DEVELOPMENT NO.:	25004623
APPLICANT:	Anthony Caruso
ADDRESS:	8 GOLDSWORTHY CR GLENELG NORTH SA 5045
NATURE OF DEVELOPMENT:	Variation of DA 22003871 – Increase Boundary Wall Height of Alfresco and Garage 2 from 3 m to 3.6 m from the Top of Footing
ZONING INFORMATION:	Zones: • General Neighbourhood Overlays: • Aircraft Noise Exposure • Airport Building Heights (Regulated) • Affordable Housing • Building Near Airfields • Hazards (Flooding - General) • Prescribed Wells Area • Regulated and Significant Tree • Stormwater Management • Urban Tree Canopy
LODGEMENT DATE:	20 Feb 2025
RELEVANT AUTHORITY:	Assessment panel at City of Holdfast Bay
PLANNING & DESIGN CODE VERSION:	P&D Code (in effect) Version 2025.3 13/2/2025
CATEGORY OF DEVELOPMENT:	Code Assessed - Performance Assessed
NOTIFICATION:	Yes
RECOMMENDING OFFICER:	Dean Spasic Development Officer - Planning

COMPROMISE PLANS:

Figure 3: Typical Boundary Gutter Detail

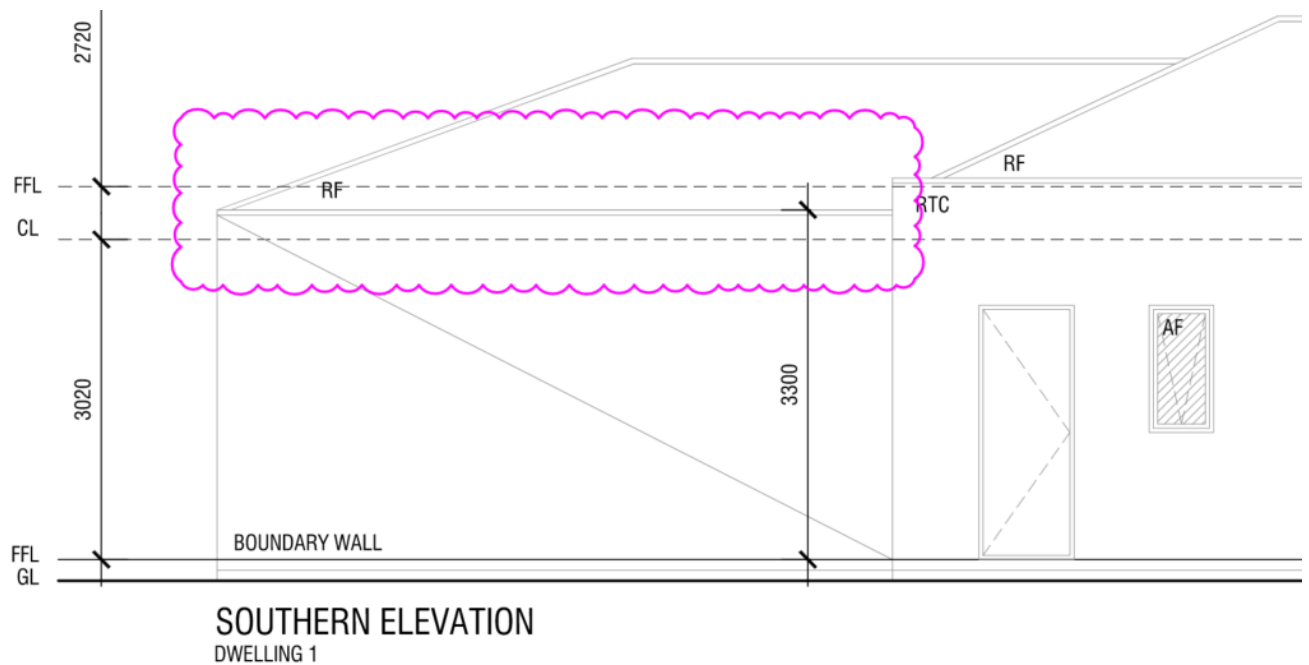
The garage wall height is reduced from 3.6 to 3.3 metres by way of incorporating a boundary gutter (charcoal colour).

The decrease in wall height is considered to reflect a positive improvement in comparison with the illegally constructed 3.6 metre high wall, which is much more visually prominent. The 3.3 metre total height is considered to be only marginally higher than the Designated Performance Feature 7.1, which is only a guideline, and is not a policy for directly determining the overall merit of a proposal.
